FROM : Anh-Long Nguyen **REF. :** 678195-0000-30CX-0001, rev. 01

OBJECT : Assessment of Water Balance and Water Quality Forecast around pond CP1 at Meliadine

Figure 3-1: Monitored and Adjusted Forecast Water Elevation in CP1 over the LOM

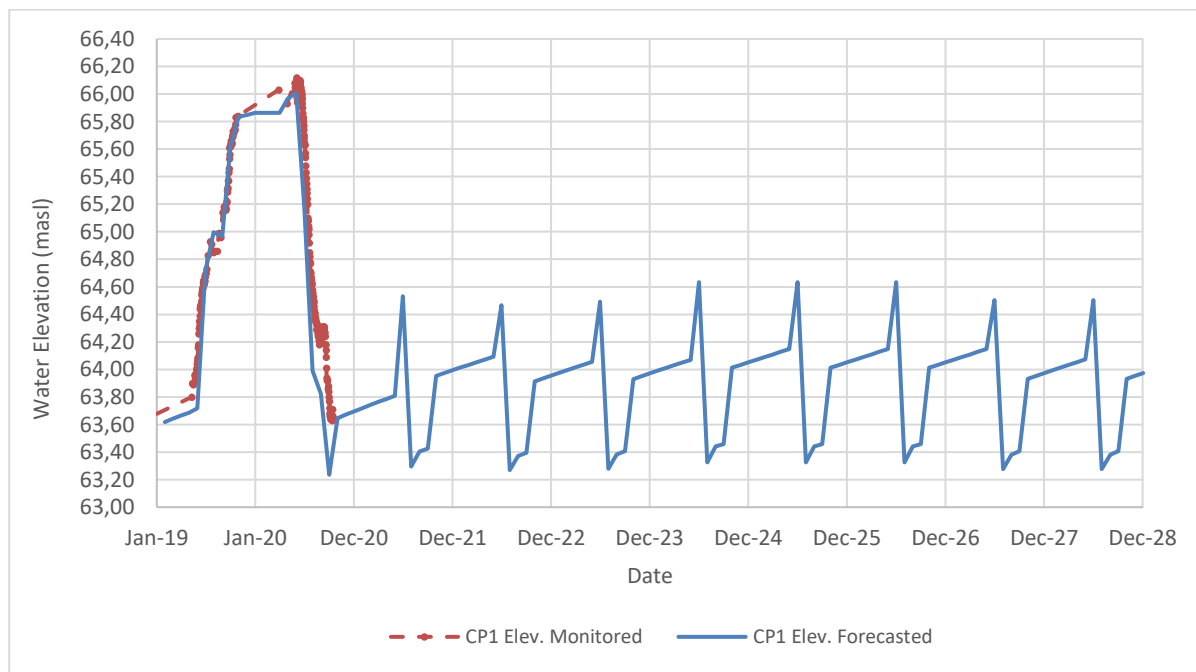
This assessment revealed that the runoff volumes considered in 2019 in the TDS lower bound model were lower than what was observed on site. The TDS lower bound model considered an average precipitation while the precipitation data collected in 2019 indicated that it was a wet-year. An adjustment factor was used to calibrate the high-level water balance model results to the 2019 monitored water elevation.

For 2020, no adjustment was required. The runoff coefficient considered at the site were adjusted in the TDS upper bound model to match the trends observed in the monitored water elevation in CP1. Thus, the results from the model suggest that all source streams reporting to CP1 are properly considered in the updated model.

Figure 3-2: Monitored and Forecast TDS in CP1 over the LOM

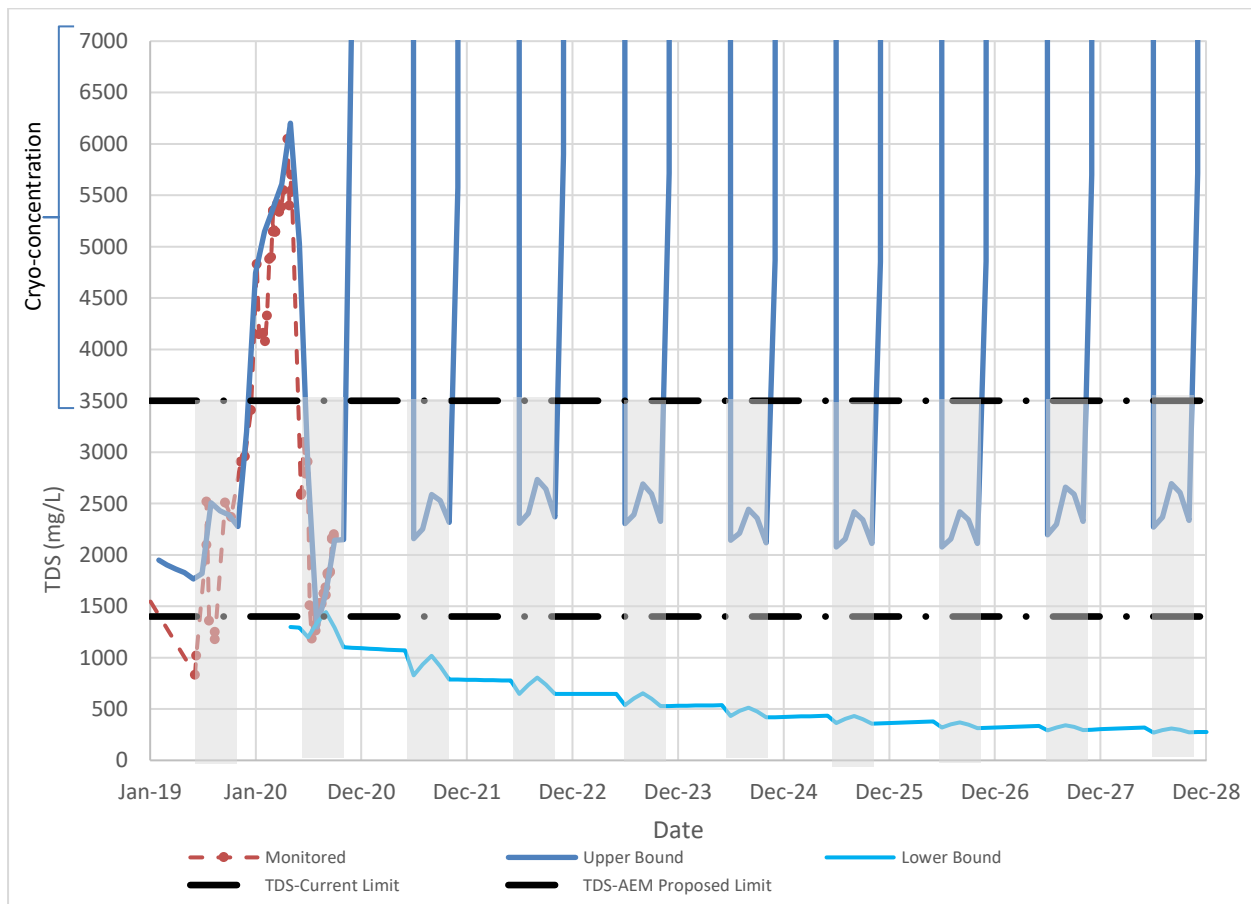
- > Forecasted TDS modelled in the upper bound scenario follow a similar trend to the monitored data when compared to the TDS lower bound model by accounting for a higher TDS load coming from the different sectors of the mine site and the tailings storage facility.

- > The TDS upper bound model was able to forecast a higher TDS concentration in September and October 2020 that trends similarly to the monitored data by considering the monitored data measured in CP3, CP4, CP5 and CP6 ponds.

- > The TDS upper bound model considers cryo-concentration due to the formation of an ice sheet that reduces the free volume in the pond over the winter months. TDS concentration are expected to increase over the winter months and then decrease once the ice sheet starts melting in June.

- > When considering the higher TDS load that could report to CP1 from runoff collected from other sectors of the mine site, the forecasted TDS concentration in CP1 during the summer months is forecasted to fluctuate around 2000 to 2500 mg/L. This forecasted concentration is higher than the current TDS discharge limit of 1400 mg/L.
